INDESIT company

Model type:
AVXL105EX

Commercial code:
F029660

1140960 Exploded views

n1040306: Reduction of cabinet depth on ARISTON EVOII 6kg washing machines produced at Bre

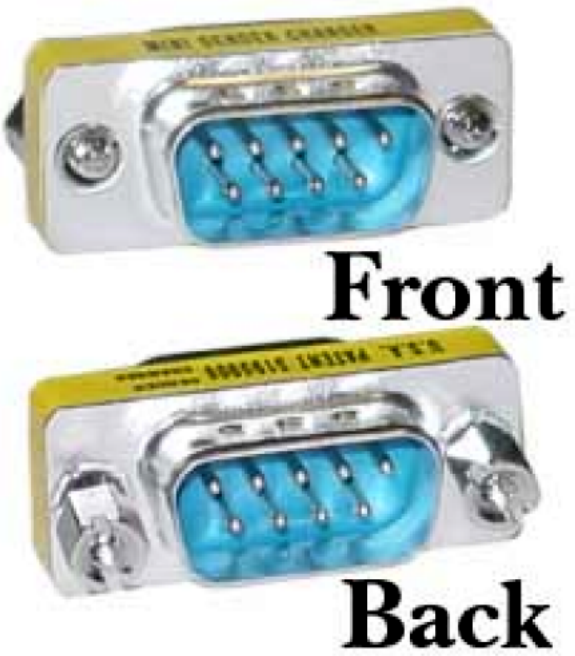
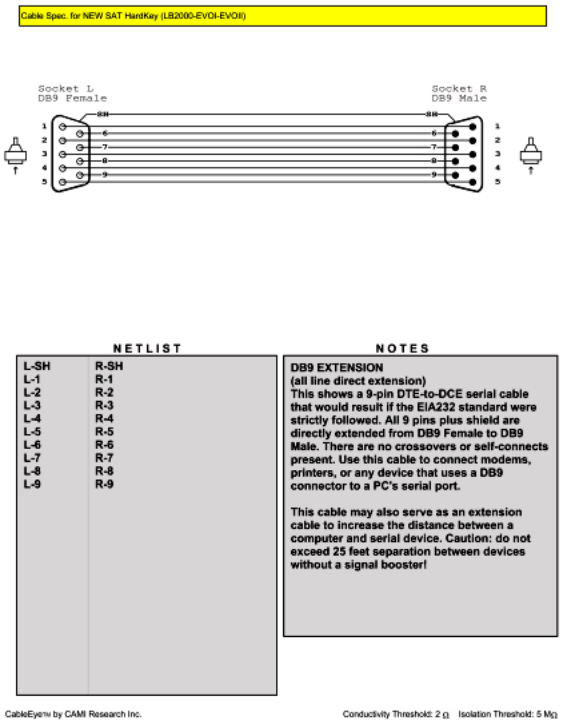
From serial no. 30915.0001, ARISTON EVOII 6kg washing machines affected by this note have been modified due to the reduced depth of the cabinet.
The modified models have a new industrial code.
The items affected by the modification are: cabinet, packing kit, top, product dispenser lid (including solenoid valve) and

solenoid valve.
Regarding the packaging kit, top, product dispenser lid and solenoid valve, the Replacements Warehouse will continue to manage premodification and new parts.
The premodification cabinets will be managed while stocks last, after which, in case of cabinet replacement the new cabinet, top and solenoid valve must be used, referring to the spare parts list for the relevant model.
Given below is a list of models affected by the modification with relevant new and premodification parts:

AVXD109EU (industrial codes: new 91296210001, premodification 91296210000);
AVXD129EX (industrial codes: new 91296220001, premodification 91296220000);
AVXL105EX (industrial codes: new 91296600001, premodification 91296600000);
AVXL109R (industrial codes: new 91297720001, premodification 91297720000);
AVXL89EU (industrial codes: new 91296230001, premodification 91296230000);
AVXD129EU (industrial codes: new 91284980101, premodification 1284980100);
AVXL109EU (industrial codes: new 91296240001, premodification 91296240000);
AVXD125FR (industrial codes: new 91284990101, premodification 91284990100);
AVXL100FR (industrial codes: new 91295430001, premodification 91295430000);
AVXL120FR (industrial codes: new 91295430001, premodification 91295430000);
AVXL88IT (industrial codes: new 91295180001, premodification 91295180000);
AVXL108IT (industrial codes: new 91284970101, premodification 91284970100);
Cabinet: premodification 095747, new 097709;

Packing kit: premodification 095741, new 094777;
Top: premodification 095738, new 097710;
Product dispenser lid (including solenoid valve): premodification 095740, new 097711;
Solenoid valve 1E2U: premodification 095739, new 097712.

AVXL105TK (industrial codes: new 91284830101, premodification 91284830100);
Cabinet: premodification 095747, new 097709;
Packing kit: premodification 095741, new 094777;
Top: premodification 095738, new 097710;
Product dispenser lid (including solenoid valve): premodification 096021, new 097715;
Solenoid valve 1E2U: premodification 095739, new 097712;
Solenoid valve 1E1U: premodification 096022, new 097716.

n1040331: Ariston LED restyling

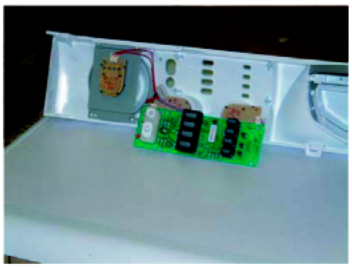
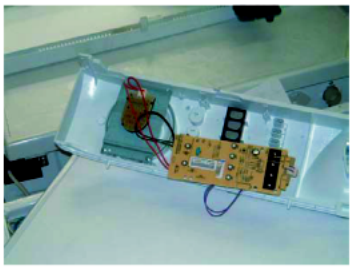
From serial no. 40429.0001, models AVL, AVXL, AVSL, AML have been equipped with a new panel with well holes for the ON/OFF and RESET buttons and flush plastic light diffusers in place of the projecting siliconed ones (see picture n10402231 Fig.02). These features determine whether an appliance is modified or premodification.
The modification has also involved the electronic card whose panel and display communication connectors are on the left and not at the back (see picture n10402232 Fig.2).

For both models
C00143338 - LED CARD EVOII AVL /BUILT-IN ARISTON
C00110115 - WHITE BUTTONS ON-OFF/RESET EVOII LED KIT
C00109854 - PANEL WIRING LBE EVOII
C00110055 - SILICONED BUTTONS AVL-AVSL
C00110059 - PANEL WIRING -DISPLAY 240000848B2.
C00111227 - WIRING MAIN - DISPLAY 24000084804B1 (POLARIZED).
The new parts are only interchangeable with the pre-modification ones if used altogether. They are not individually interchangeable.

This modification progressively involves all models of the Ariston Led range. The last two numbers of the Industrial Code for the modified models is 50 (e.g. 80299050050).

n1040381: Drain pump with bayonet-style filter - front Loading Brembate

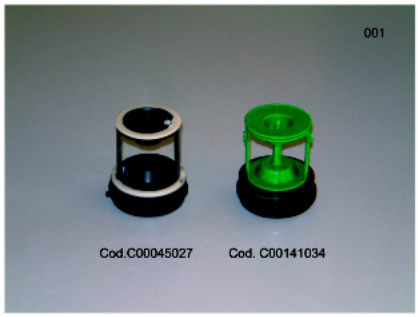
From serial no. 50720.0001 a new drain pump with bayonet-style filter has been installed on all front loading washing machines manufactured in Brembate.

New parts:
C00119307 - Drain pump
C00141034 - Pump filter kit

Premodification parts:
C00092264 - Drain pump
C00045027 - Pump filter kit

The new parts can be used instead of premodification ones.
